DeKalb County's Response to Appeal

N8. Case No: A-26-1247835 Parcel ID(s): 18 232 09 049

Appeal of: Administrative Decision regarding stream buffer encroachment

Project Name: 2798 Overlook Drive – Home Addition

PROPOSED BUFFER ENCROACHMENTS DETAIL

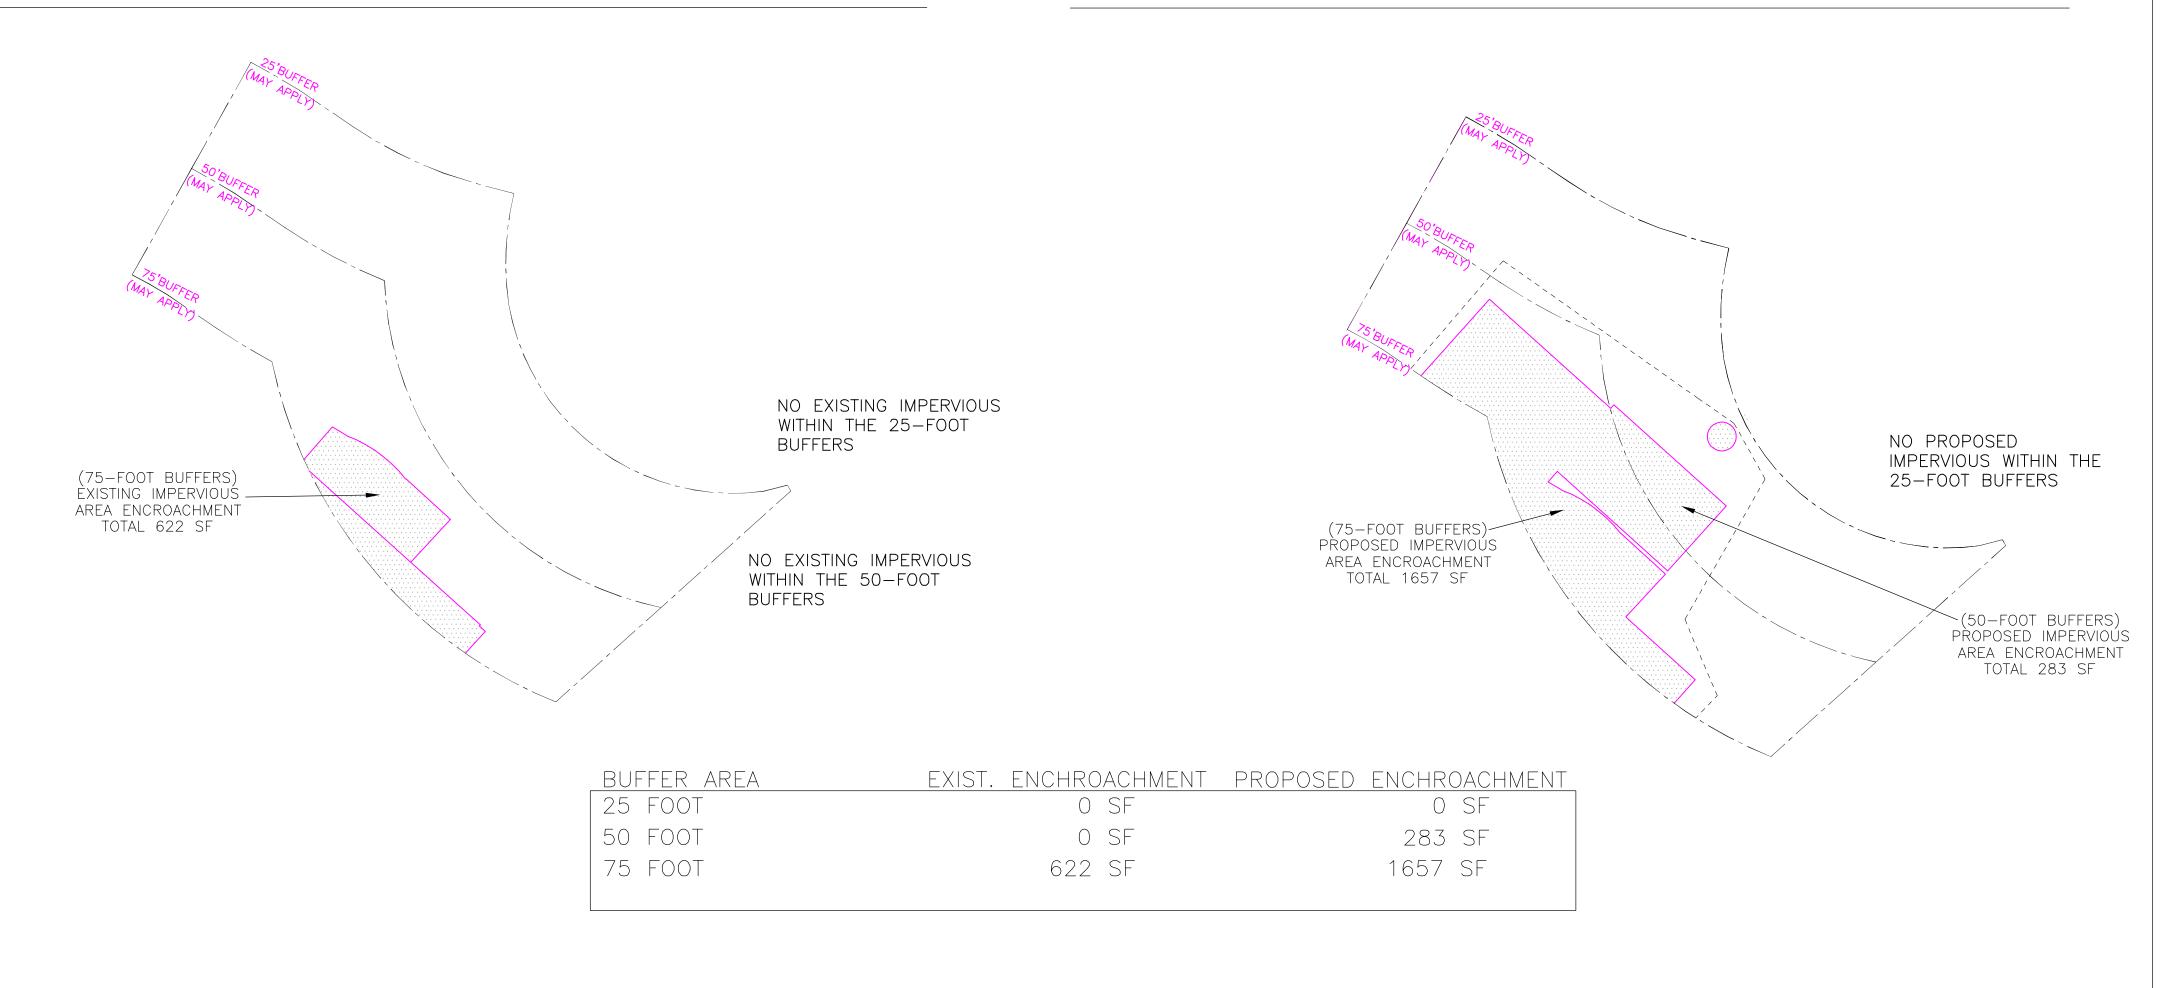
The applicants propose a backyard improvement project including a retaining wall, an expanded deck, and a swimming pool. The plans submitted indicate an encroachment of approximately 283 square feet into the regulated 25–50 foot county stream buffer. No portion of the project is proposed within the inner 25-foot no-disturb zone.

The proposed encroachment of 283 square feet, while limited in area, is associated with the installation of new recreational improvements rather than essential structural or safety-related remediation. The retaining wall justification is tied to expansion of usable living area, not the stabilization of existing permitted structures alone. Land Development correctly concluded that the proposed layout did not represent the minimum possible disturbance and that feasible configurations exist outside the 25–50 foot buffer.

Neighbor support letters are acknowledged; however, buffer regulations are intended to safeguard environmental performance and watershed function and are not subject to neighborhood preference. The proposed project introduces additional impervious surface and structural components within a regulated stream buffer, raising concerns regarding cumulative watershed impacts. Stormwater proposals such as flo-wells and slate chips do not replace the ecological function of the undisturbed buffer required by Section 14-44.1. Land Development's decision prioritized countywide environmental standards in accordance with ordinance requirements.

Recommendation: Affirm the administrative denial.
